Re: EQT Production Company- OXF 157 Proposed Well Pad, Associated Pit, and Access Road Modification

**OXF 157 Well Pad, Pit and Access Road Modification**

**Purpose of development: Well Pad, Associated Pit and Access Road Modification**

**Stream Crossing "A" Details**

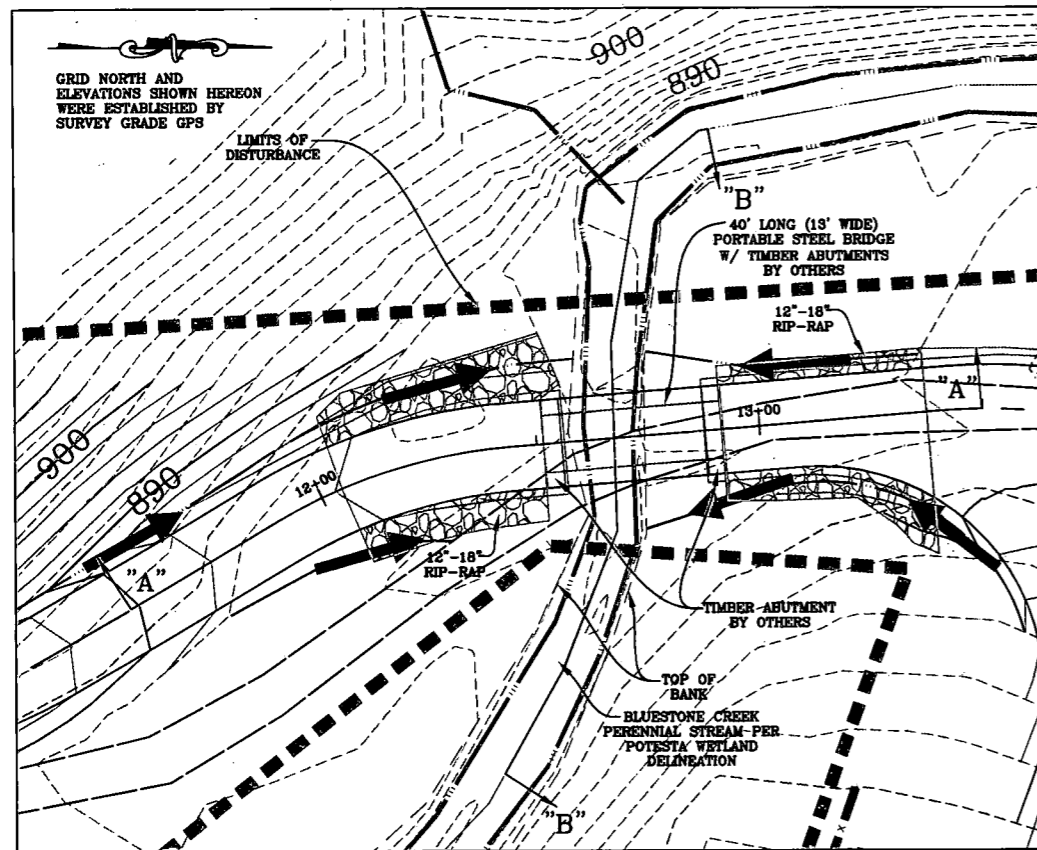
### Stream Crossing A (Sheet 21 of Site Plans Revised 6/03/2014)

- **Temporary Crossing:**
  - The original design (Sheet 20 of Original Site Plans dated 11/04/2013) for “Stream Crossing A” Temporary Crossing showed clean rock fill 6” of 2”-4” coarse aggregate with large angular rock and a 40’ temporary steel bridge.
  - The revised site plans show a 40’ temporary steel bridge with 12”-18” rip-rap side slopes.
- **Permanent Crossing:**
  - The original design had a proposed permanent crossing with (4) 18” CMP culverts.
  - The revised design does not show a permanent crossing because this portion of the access road leads to the pit area. After construction is completed this area is going to be reclaimed in the required amount of time. Because of this, this road will no longer be used and a permanent stream crossing is not necessary.

**Stream Crossing "B" Details**

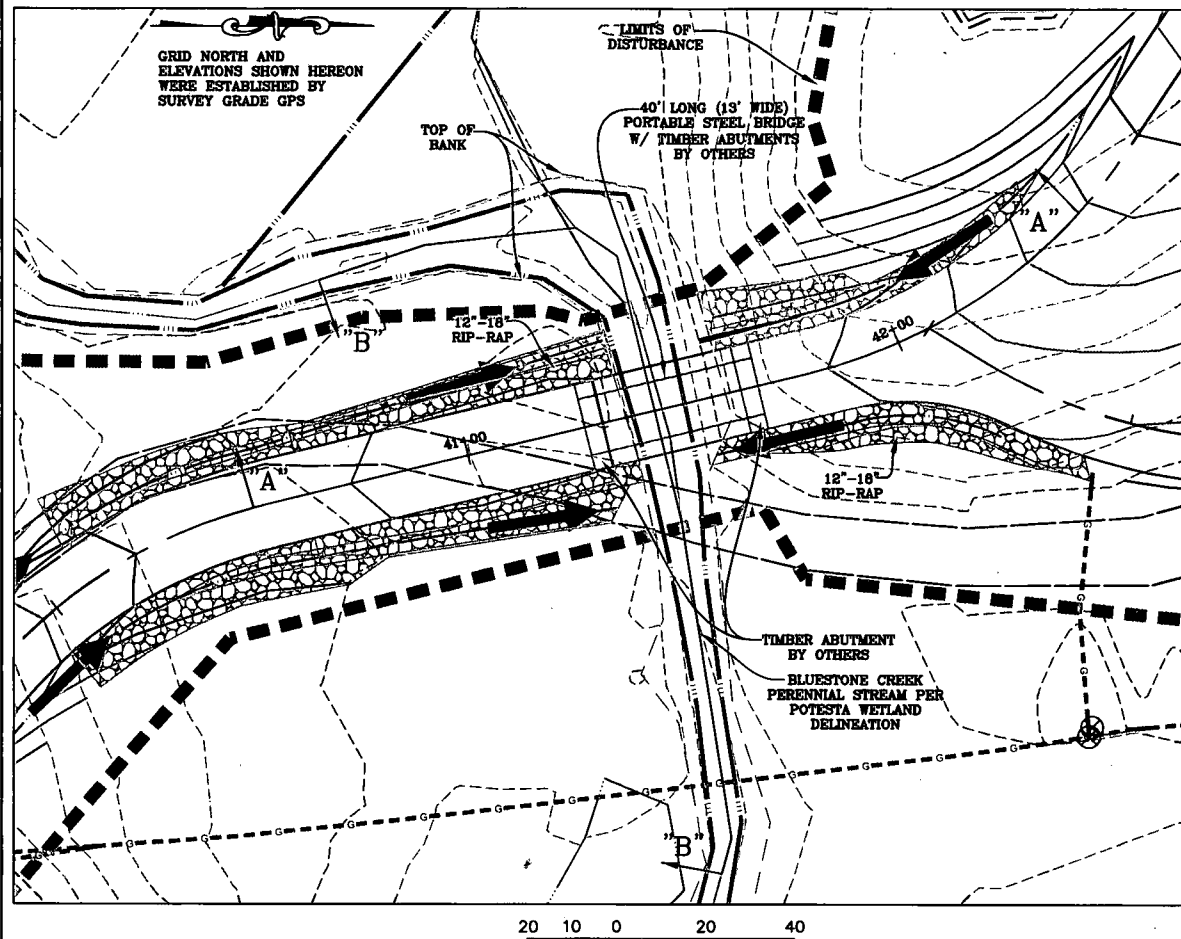
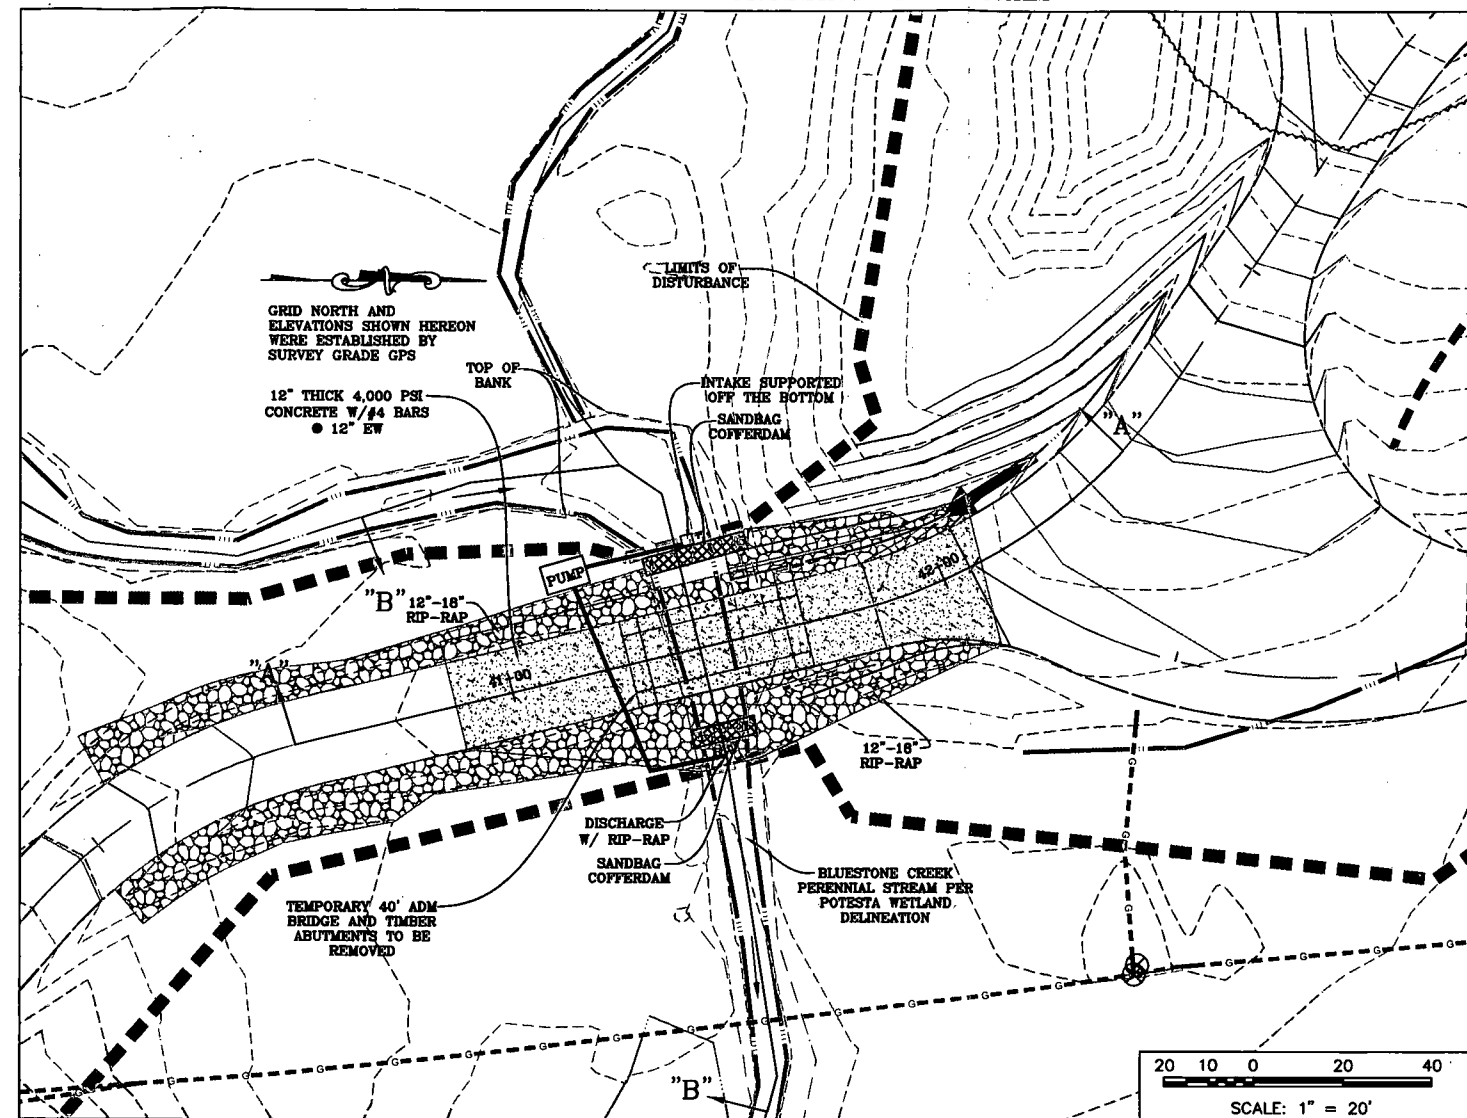
### Stream Crossing B (Sheet 22 of Site Plans Revised 6/03/2014)

- **Temporary Crossing:**
  - The original design (Sheet 21 of Original Site Plans dated 11/04/2013) for “Stream Crossing B” Temporary Crossing showed clean rock fill 6” of 2”-4” coarse angular rock and a 40’ temporary steel bridge.
  - The revised site plans show a 40’ temporary steel bridge with 12”-18” rip-rap side slopes.
- **Permanent Crossing:**
  - The original design had a proposed permanent crossing with (4) 18” CMP culverts.
  - The revised design shows the permanent crossing where the temporary bridge will be removed and a concrete low water ford crossing will be constructed. This low water ford will be comprised of 12” thick 4,000 PSI concrete reinforced with #4 rebar 12” each way and will have 12”-18” of rip rap. During construction, a sandbag cofferdam will be

**Stream Crossing "C" Details**

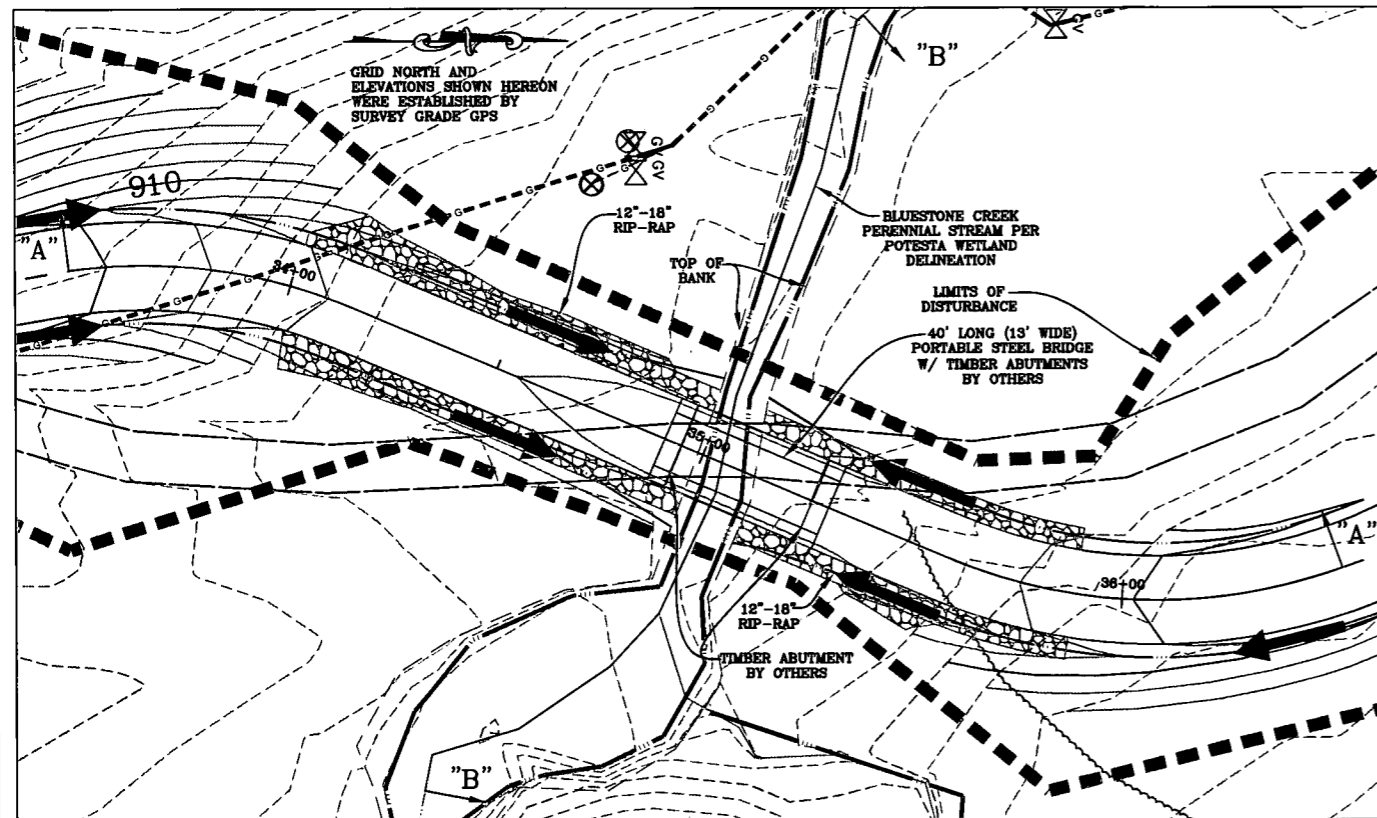
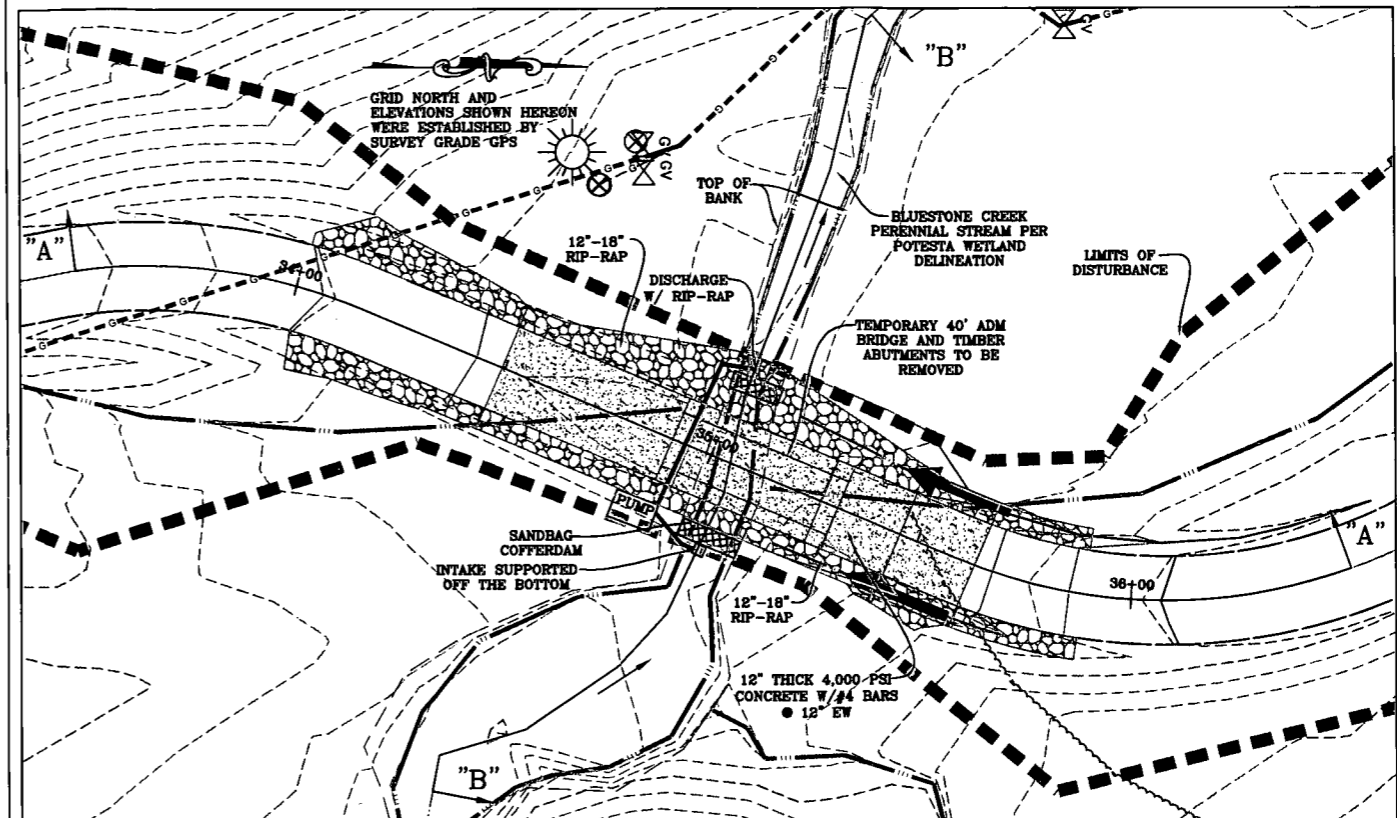
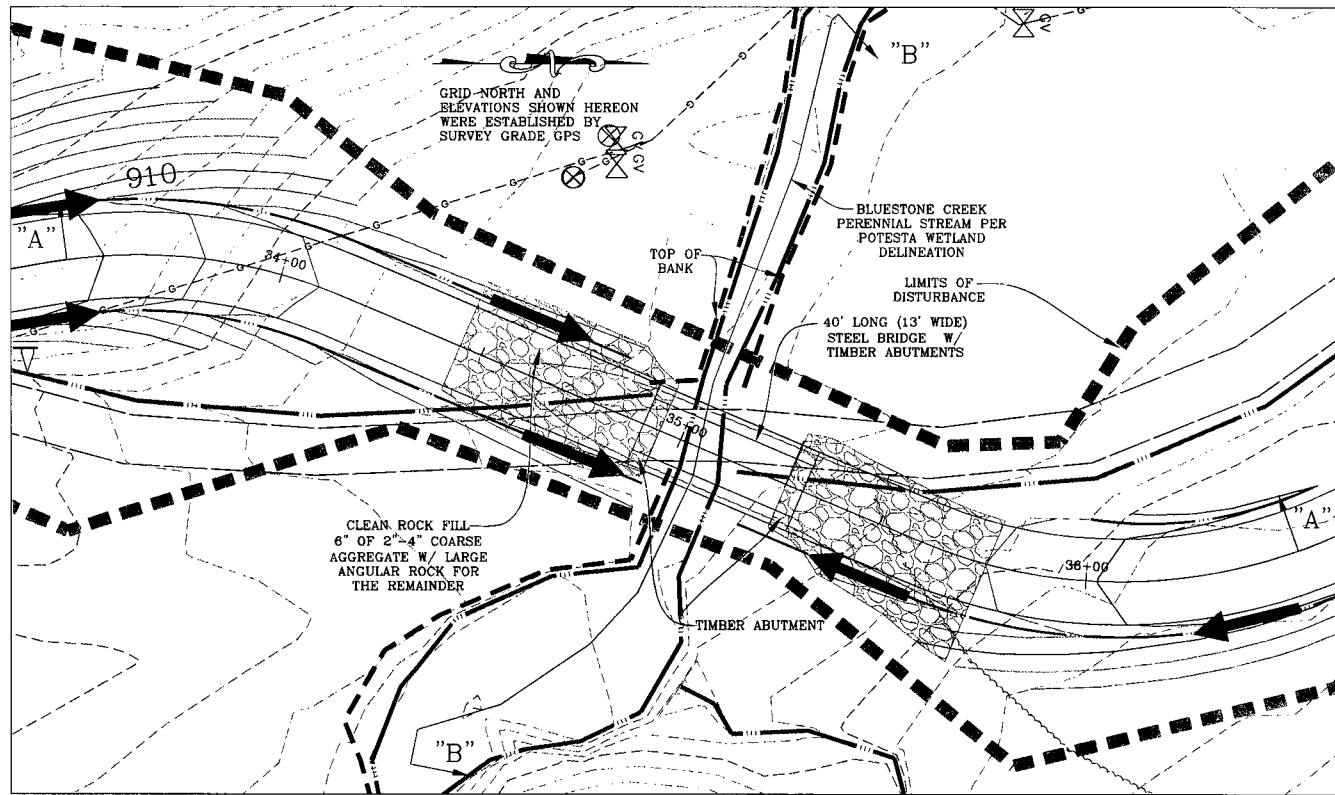
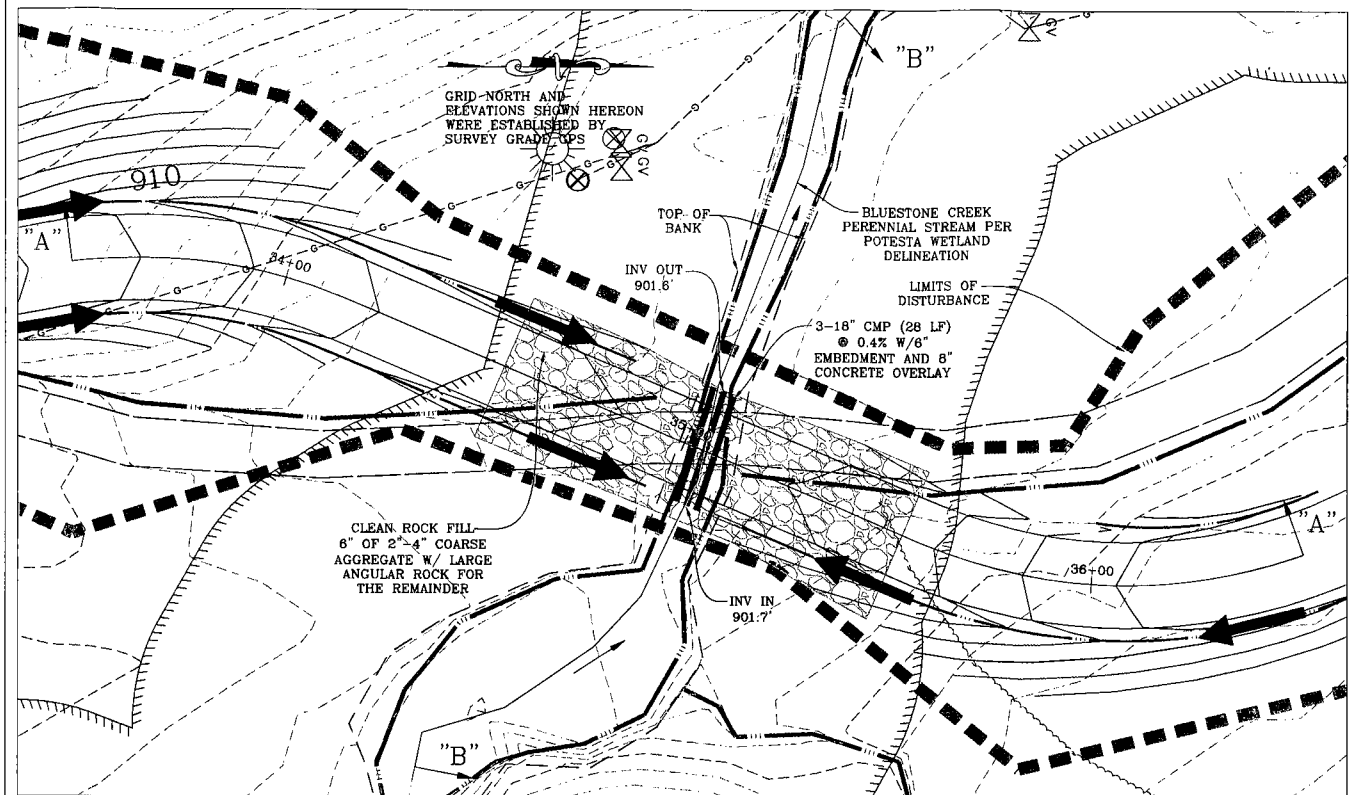
### **Stream Crossing C (Sheet 23 of Site Plans Revised 6/03/2014)**

- **Temporary Crossing:**
  - The original design (Sheet 23 of Original Site Plans dated 11/04/2013) for “Stream Crossing C” Temporary Crossing showed clean rock fill 6” of 2”-4” coarse aggregate with large angular rock and a 40’ temporary steel bridge.

- The revised site plans show a 40’ temporary steel bridge with 12”-18” rip-rap side slopes.
- **Permanent Crossing:**
  - The original design had a proposed permanent crossing with (3) 18” CMP culverts.

- The revised design shows the permanent crossing where the temporary bridge will be removed and a concrete low water ford crossing will be constructed. This low water ford will be comprised of 12” thick 4,000 PSI concrete reinforced with #4 rebar 12” each way and will have 12”-18” of rip rap. During construction, a sandbag cofferdam will be placed on the inlet and outlet sides of the stream crossing. The water will then be pumped around while the low water crossing is being constructed.
